NRC REQUEST NUMBER ONE FOR ADDITIONAL INFORMATION ON UNC-S-8000(P)

Enclosure 1 states UNC's proposed resolutions to your April 5, 1984 comments and questions regarding UNC's Licensing Topical Report, UNC-S-8000(P), UNC Portland Cement/Sodium Silicate Radwaste Solidification System.

UNC'S RECOMMENDED RESOLUTIONS TO NRC COMMENTS
ON TOPICAL REPORT UNC-S-8600(P)

(UNC Document No. UNC-S-8000, Vol. I & II, January 1983)

UNITED NUCLEAR INDUSTRIES, INC.
EQUIPMENT ARRANGEMENT
EL 731-0
WASTE SOLIDIFICATION SYSTEM

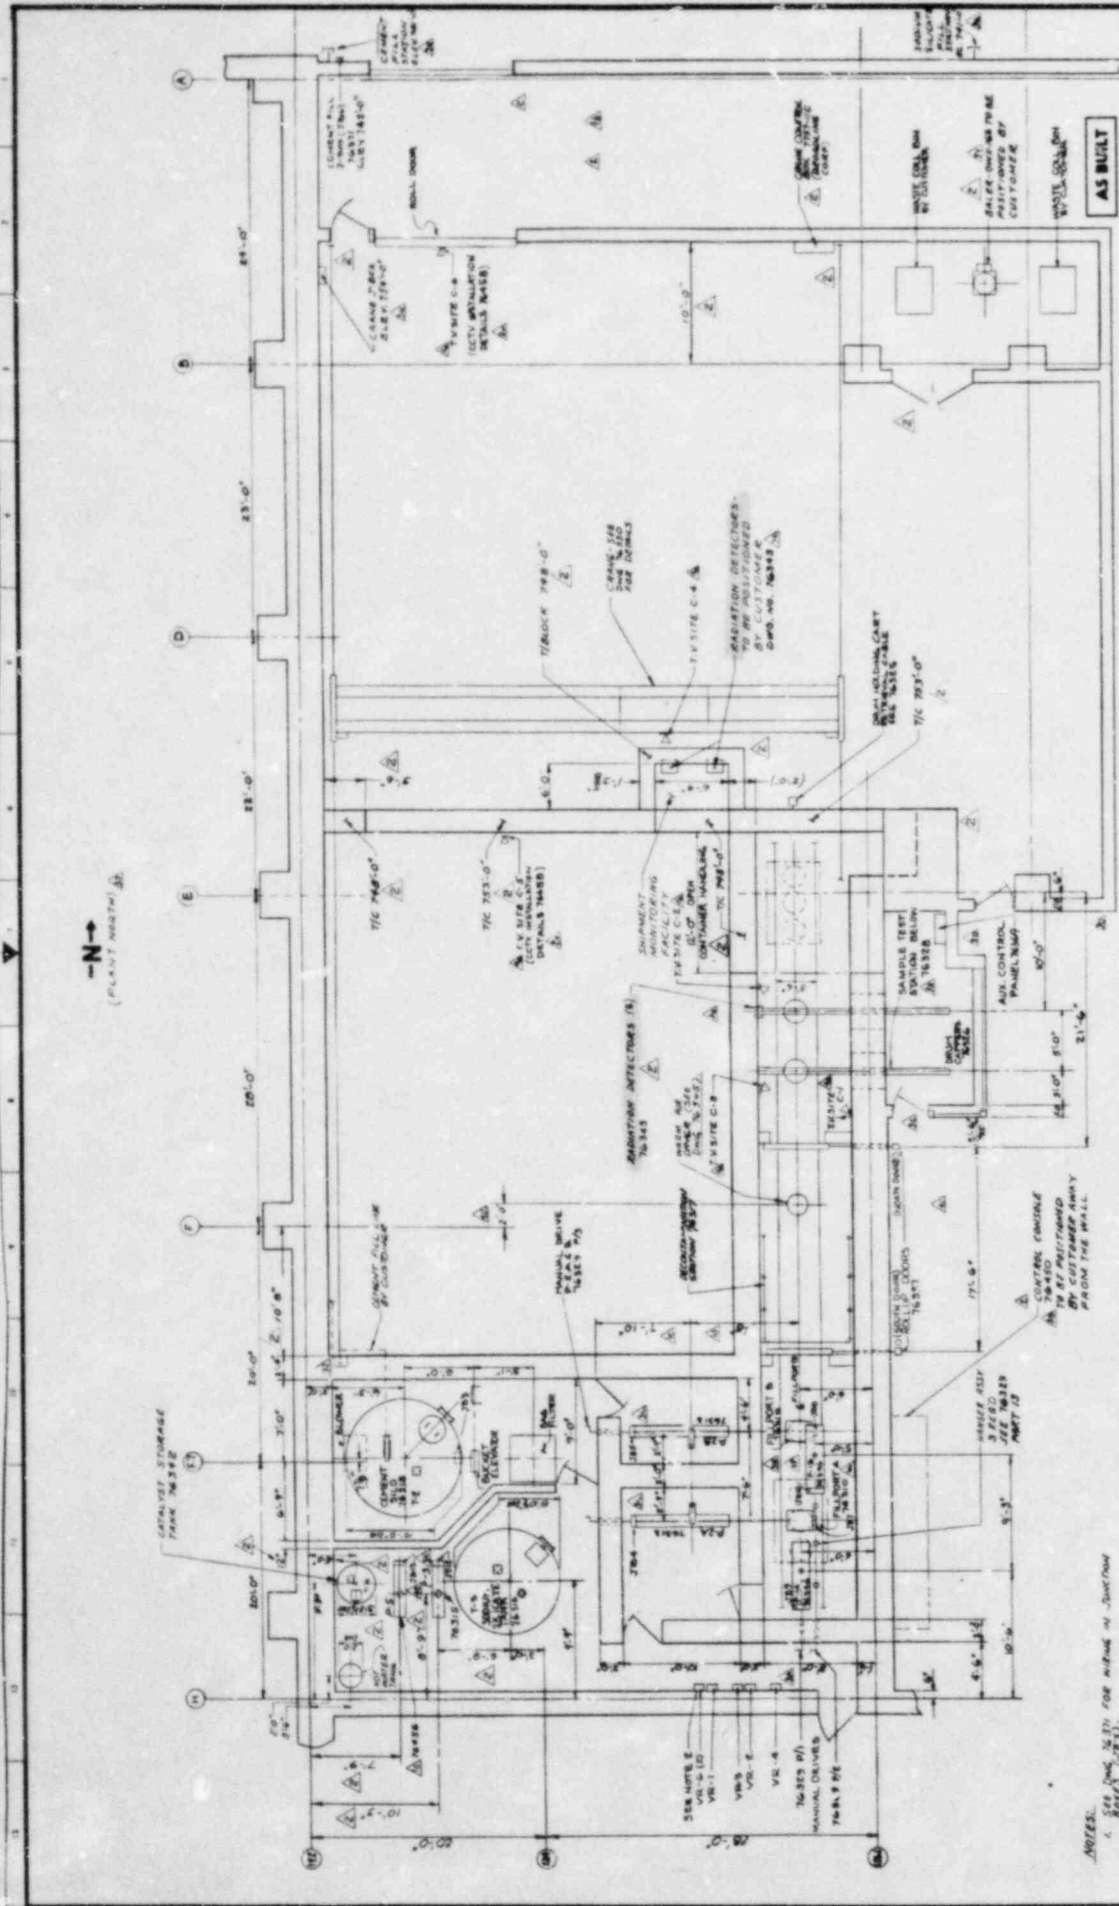
12. Comment: "Page 2-14, Section 2.3.4.
"Explain or elaborate on the 'inventory management and system control purposes' of the Radiation Monitoring System. Also, more detailed information is needed about this system. Include the basis for the types and ranges of instruments used, as well as any requirements for calibration and maintenance. The Radiation Monitoring System should be included in the Piping and Instrumentation Diagram. (See General Design Criteria 63 and 64 in 10 CFR 50). Near the end of the section, should 'columnating' be 'collimating?'"

The Marble Hill Station did not order radiation monitors with their radwaste equipment. Therefore, UNC is providing a P&ID and arrangement drawing for the RSS provided to the Clinton Nuclear Station (Enclosure 3), which identify radiation monitors for the drum cappers and loadout area.

The radiation monitors provided by UNC meet design criteria 63 and 64 in Appendix A of 10 CFR 50. The equipment provided delivers a full range of capabilities required for the local monitoring and measurement of radiation fields in the radwaste solidification equipment modules and loaded radwaste containers. Note, however, that the customer is responsible for meeting the full range of 10 CFR 50 criteria.
